# ADDENDUM

ADDENDUM NO: 2

PROJECT: Hamilton Heights High School Phase 2 Projects

DATE: 02/27/2024

21 TYPICAL DETAIL AT EXTERIOR DOOR  
S401 SCALE: 3/4\"/>

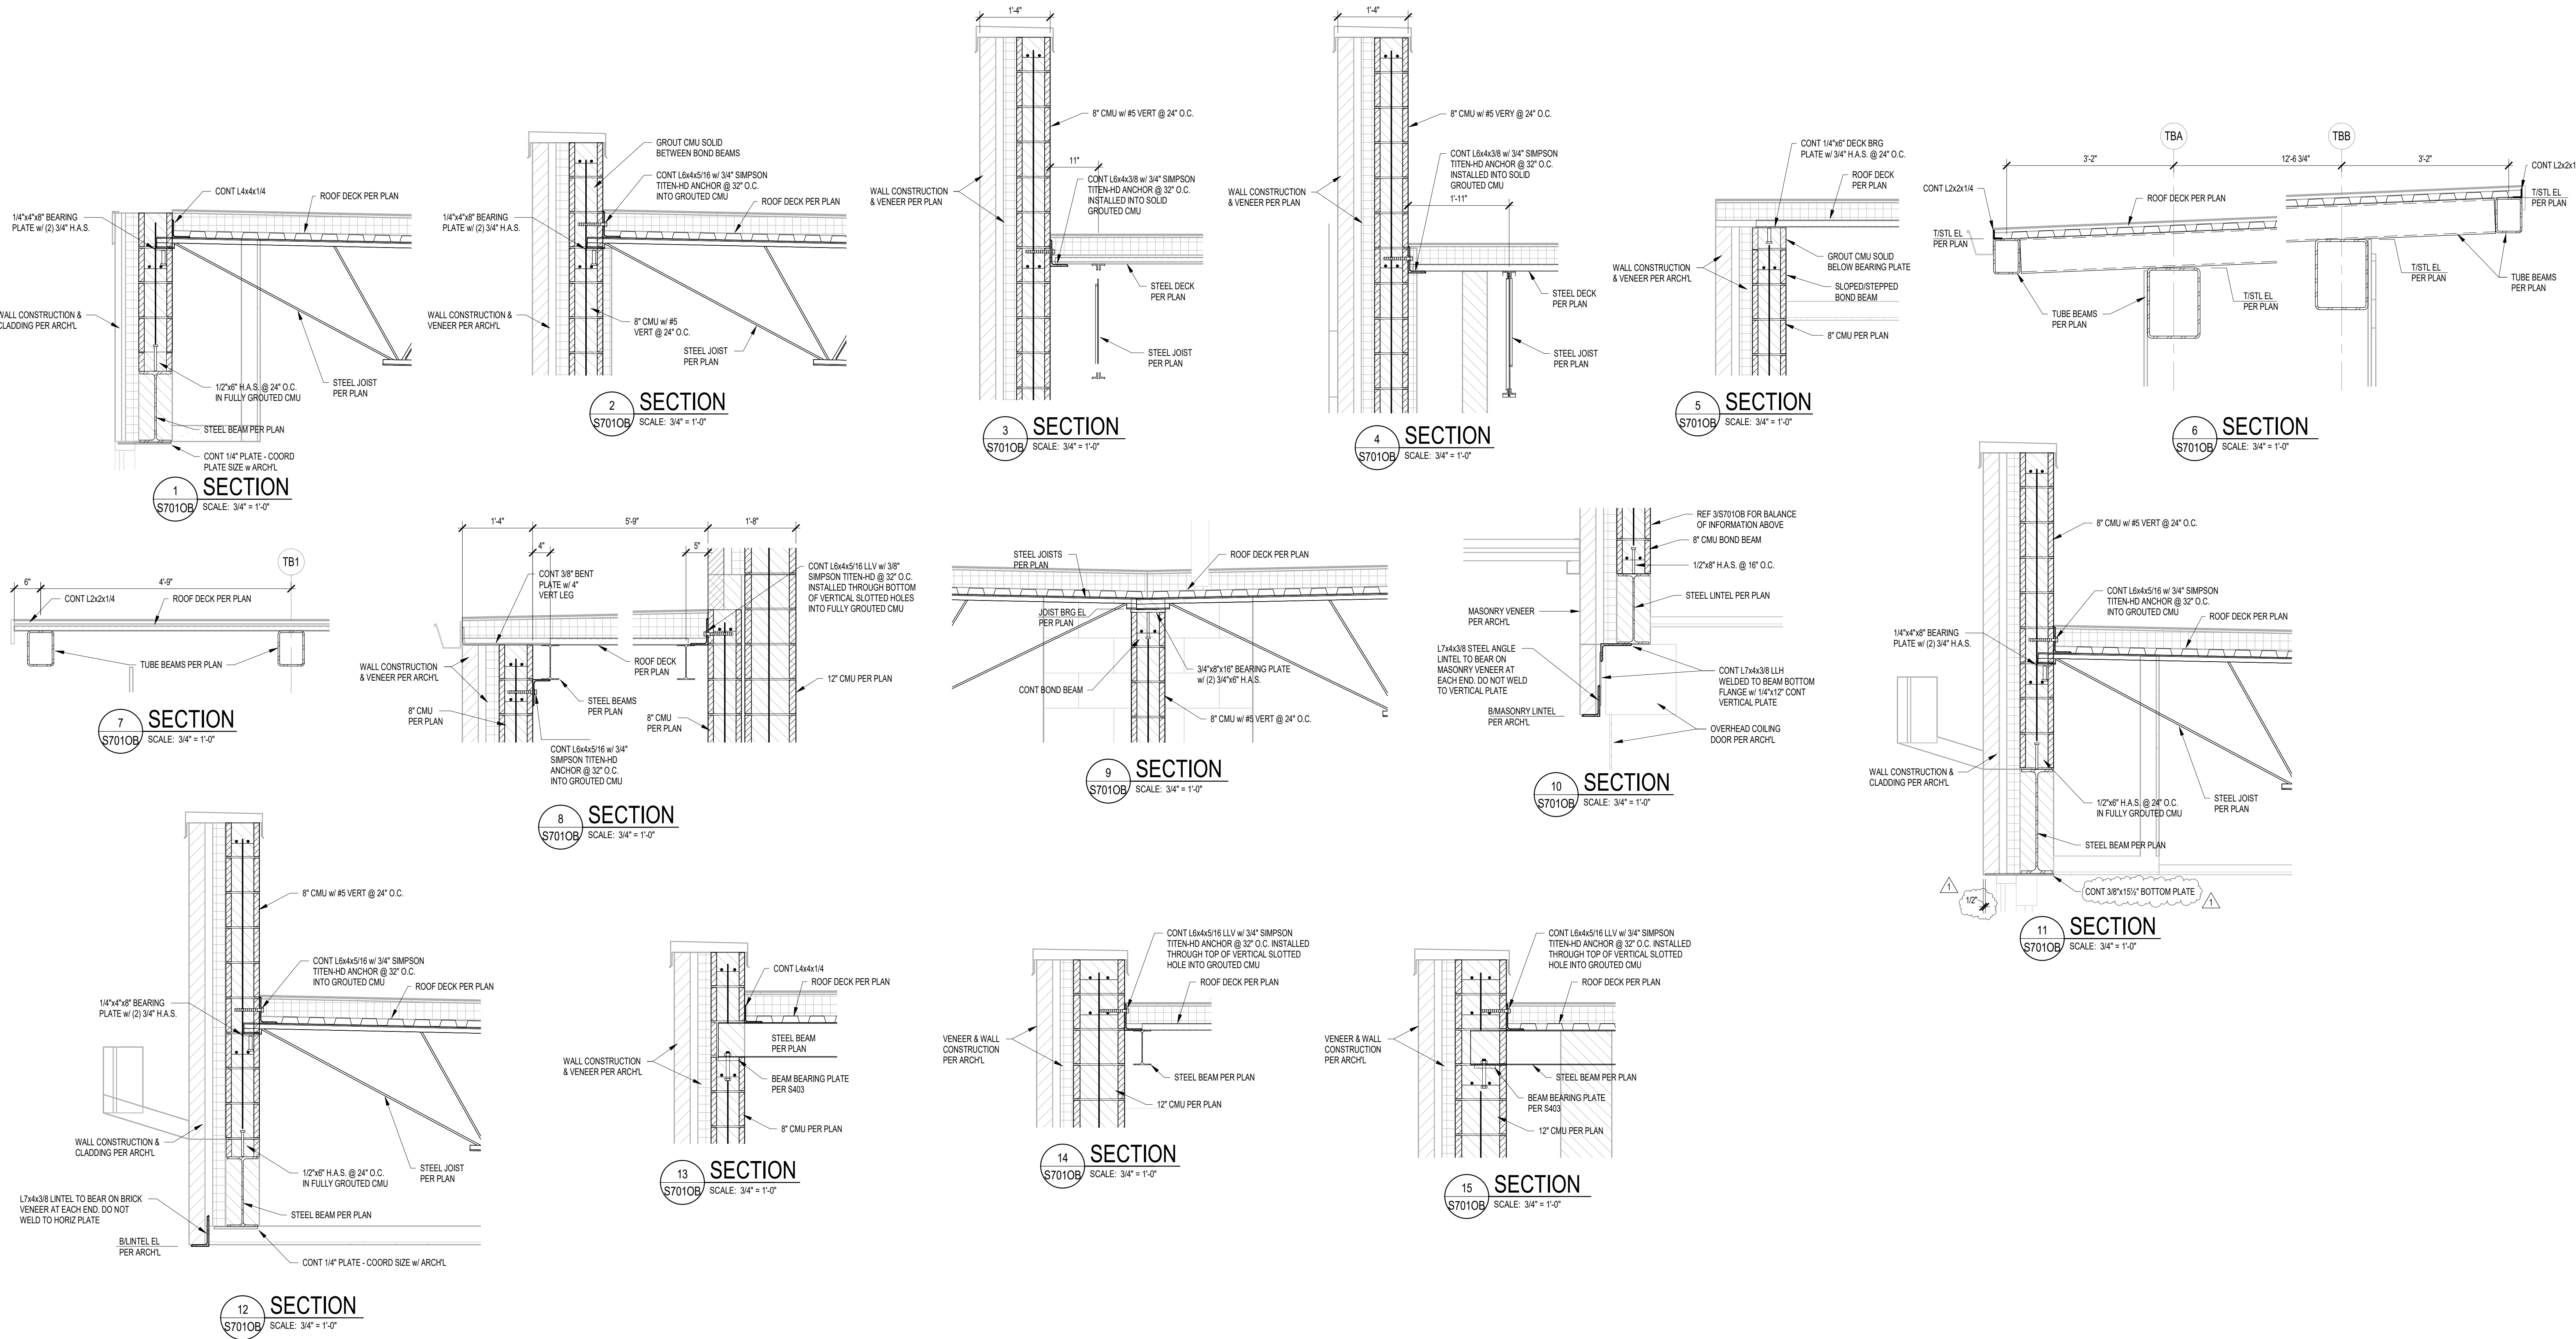
- A. Detail 21, "Typical Detail at Exterior Door" shall be revised as shown on the attached drawing.
